PLANNING COMMISSION REPORT REGULAR AGENDA --NON-PUBLIC HEARING ITEM:

PC Staff Report 05/18/2009

ITEM NO. 1: PRELIMINARY PLAT; FIFTH STREET BLUFF SUBDIVISION; .29

PP-04-01-08: Consider the Preliminary Plat for Fifth Street Bluff Subdivision, a 0.29 acre

Figure 1. Purple highlighted area is the subject property. Distance of street section marked with the red arrow is approximately 272 ft. The change in elevation is 20 ft (the bold contour lines mark 10 ft change in elevation).

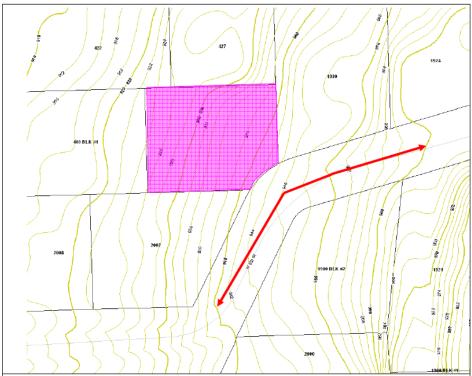
The public comment received related primarily to safety concerns related to the steepness of the road in this area. Percent slope is calculated with the following ratio: % Slope =(Change in elevation [rise] / Change in distance [run]) x 100. The sight distance study included the elevation of the road for 160 ft to the west of the centerline of the driveway and 225 ft to the east for a total distance of 385 ft. The study indicates that the elevation of the road varies from 961 ft on the east to 932 ft on the west for a change in elevation of 29 ft. The slope of the road in this area is approximately 7.5%. [% slope = rise/run x 100; 29/385 x 100 = 7.5%] Other streets within the City of Lawrence with similar or steeper grades include Morning Dove Circle located south of Stonegate Park near I-70 with a grade of 9.05%; W 12th Street west of Indiana Street with a grade of 14%; and W Hills Parkway with a grade of 8.2%. The general layout of the proposed lot and W 5th Street is shown in Figure 1. Attachment A contains a comparison of Morning Dove Circle and W 5th Street.

Figure 2. The proposed lot, outlined in red, is compatible with the size and shape of existing lots in the area.

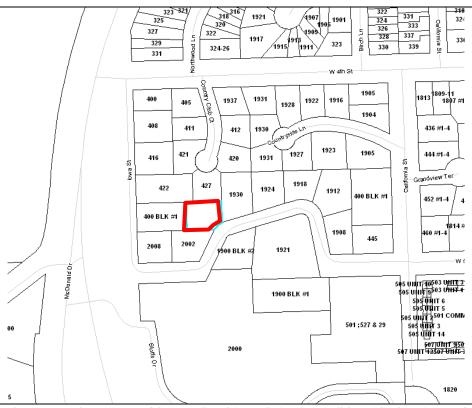
Horizon 2020 recommends that the character and appearance of existing low-density residential neighborhoods should be protected through compatible infill development. This plat creates a 12,702 sq. ft. lot. Nearby lots are within the 10,700 sq. ft. to 17,194 sq. ft. range. (See Figure 2) The lot being created with this plat is compatible with the existing lots.
